<b>Errata      IBC Chapter 2 Definitions</b>
--

**Code/Standard:** IBC 2021

**Applies to following Printings:** 1<sup>st</sup> and 2<sup>nd</sup>

Section/Table/Figure Number: 2113.19

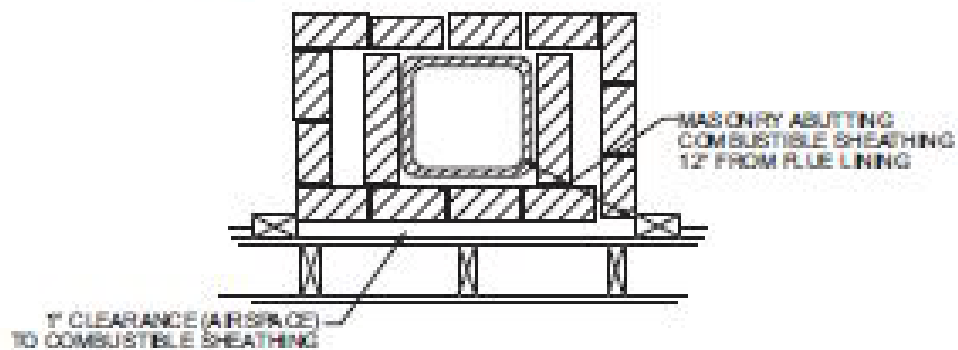
Replace Figure 2113.19 with the following:
